SUBJECT: RESPONSE TO COMMENTS ON THE DRAFT FINAL  
REMEDIAL INVESTIGATION WORK PLAN FOR SITE 17  
NAVAL AIR STATION (NAS) BRUNSWICK, MAINE

Enclosed are responses to comments (RTCs) received from the U.S. Environmental Protection Agency (EPA), dated February 21, 2008, and the Maine Department of Environmental Protection (MEDEP), dated March 12, 2008 on the Draft Final Remedial Investigation Work Plan for Site 17.

**Response to Comments  
From EPA on the  
Draft Final Site 17 Work Plan –UFP SAP**

**Response to Comments  
From Maine DEP on the  
Draft Final Site 17 Work Plan –UFP SAP**

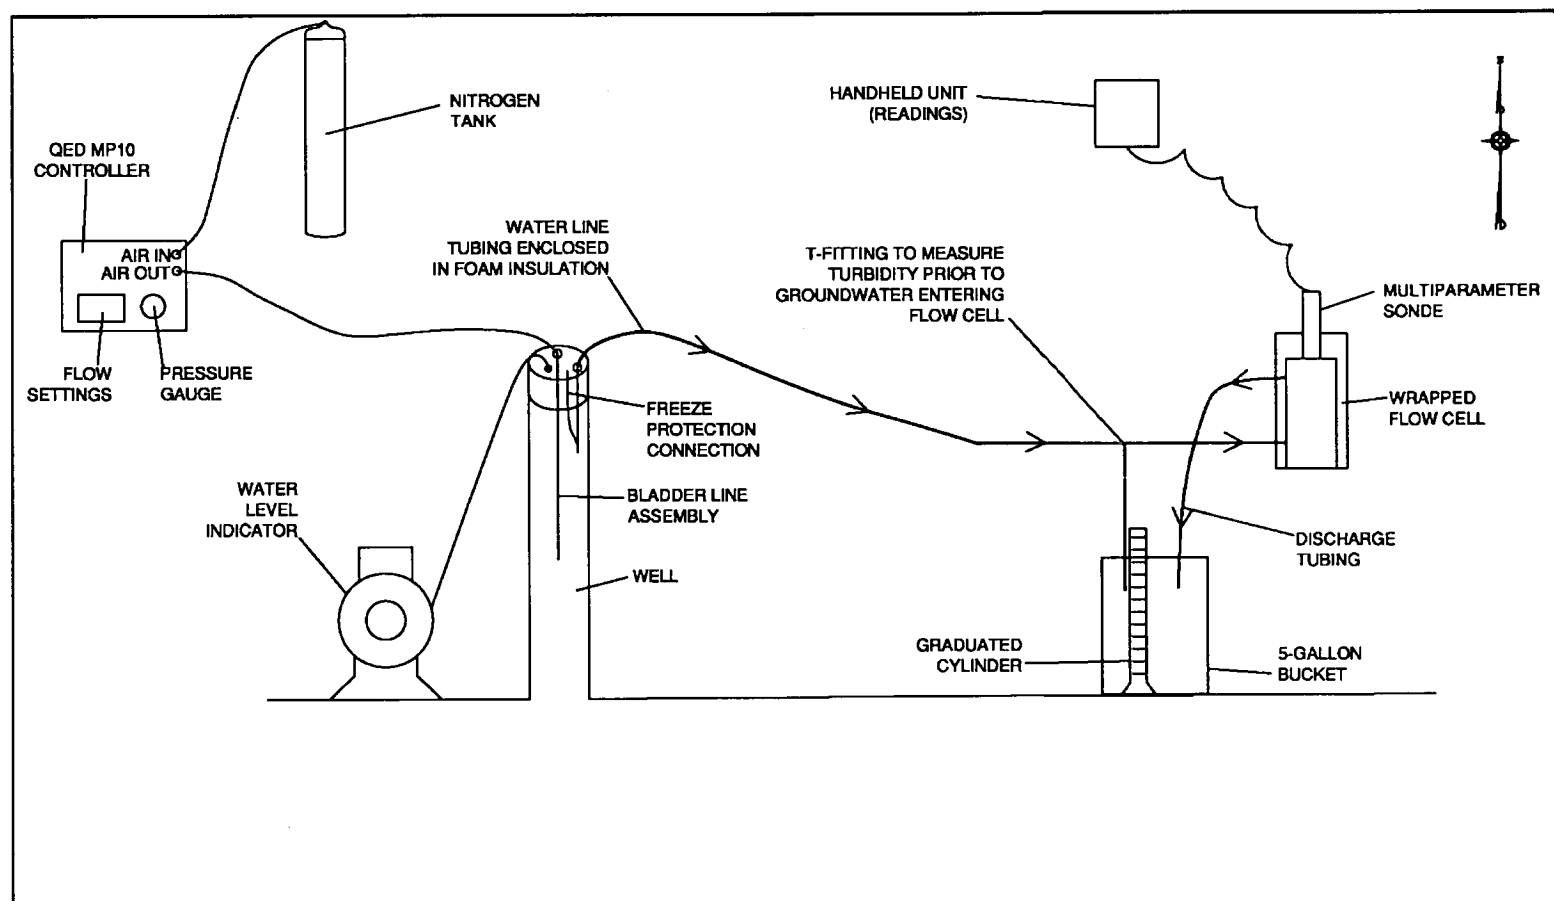
9. **Appendix A – Worksheet #22 Field Equipment Calibration, Maintenance, Testing and Inspection Table:** For the quality meter, the Acceptance Criteria is listed as "manufacturer guidance". The acceptance criteria are the criteria that meet the objective of the project. It may or may not be the same as the manufacturer specifications. Therefore, the acceptance criteria need to be described in the Table.

Response: The actual criteria will replace the words manufacturer's guidance.
